Technical Memorandum

Date:	07/16/2022
To:	Dick Vander Schaaf, Project Manager Associate Coast and Marine Conservation Director The Nature Conservancy of Oregon
From:	Curtis Loeb, PE, Principal Engineer Rowyn Cooper-Caroselli, PE, Lead Modeler Wolf Water Resources Portland, OR
Project:	Porter Tract Restoration - Kilchis Estuary Preserve
Subject:	Hydrodynamic Model Refinements in Response to Hydraulic Review

Figure 2 Summary of actions/ model scenarios developed to refine and improve the Porter Tract Restoration; model output locations are also shown for reference.

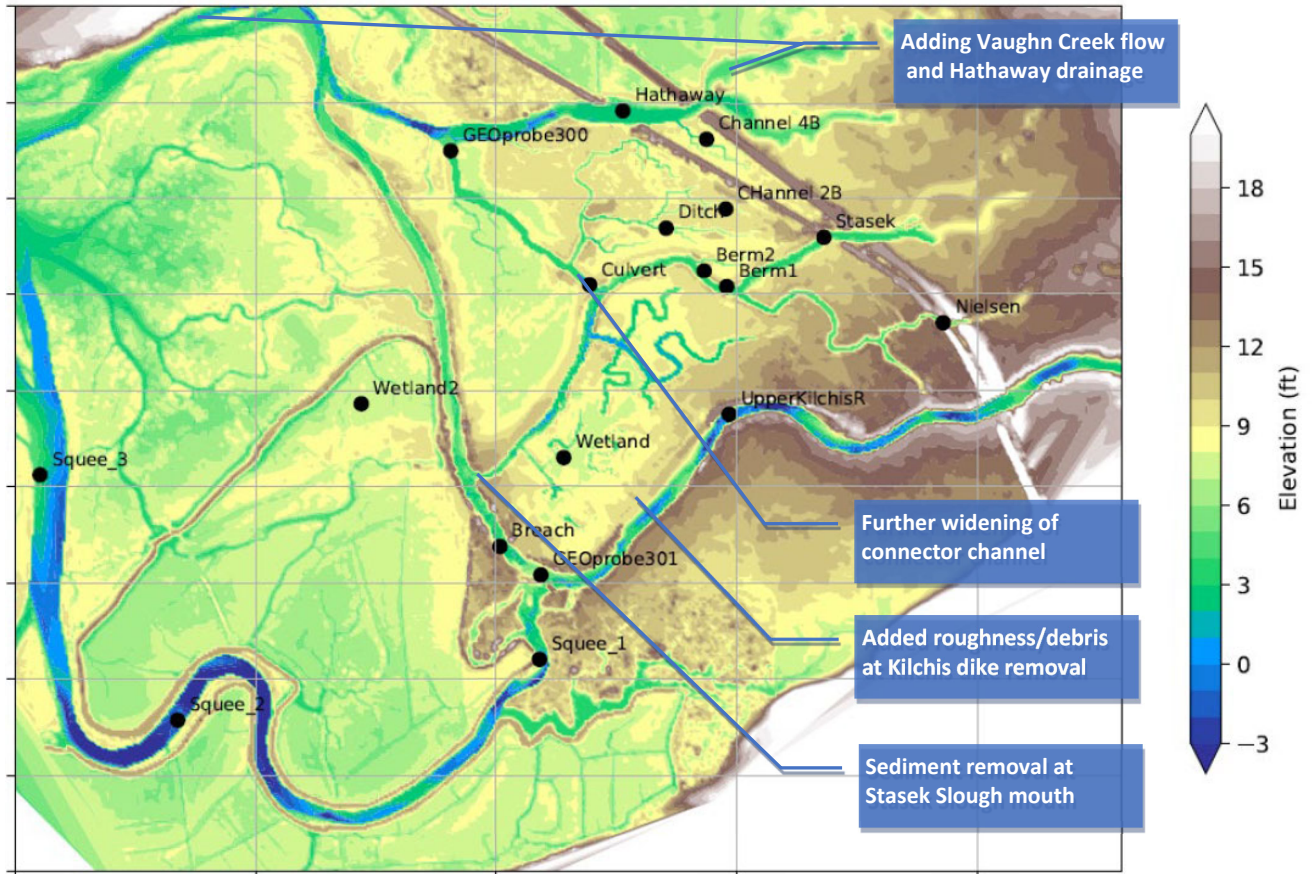
1. **Winter events:** consider more common or frequent winter river and tide levels rather than extreme or more rare combined events,
2. **Vaughn Creek:** adding tributary flows from Vaughn Creek, located north of the Hathaway Slough drainage, into the model,
3. **Connector Channel:** further widen the Stasek Slough connector channel,
4. **Stasek Berm:** would retaining the Stasek and Hathaway berms (as proposed in the Porter Tract Restoration) reduce inundation upstream,
5. **Highway 101 drainage:** consider new drainage paths or channels between the railroad and Highway 101 embankments,
6. **Stasek sedimentation:** removing sediment from Stasek Slough near the mouth where the 2015 storm deposited sediment in the channel,
7. **Other potential refinements** to improve drainage especially during common winter periods.

Model scenarios were developed to address items 1, 2, 3, 6, and 7. Item 4, Stasek Berm, was not evaluated further because it is clear through inspection of prior model results that these low, discontinuous berms do not impede overland or in-channel flows from tidal events or Kilchis River overflows. Item 5, Highway 101 drainage, was also not considered explicitly as the current Porter Tract Restoration (base case) already includes a new drainage channel and removal of drainage impairments (old tide gate and earthen berm), and it was unsure how to improve drainage further from this region. Item 7 includes evaluation of bank treatments along the Kilchis River where the levee was removed as part of the Kilchis Restoration (Phase 1, or Dooher Tract Restoration) – see Model Refinements Section of this memo. A summary map showing model changes and/or elements considered is shown in Figure 2.
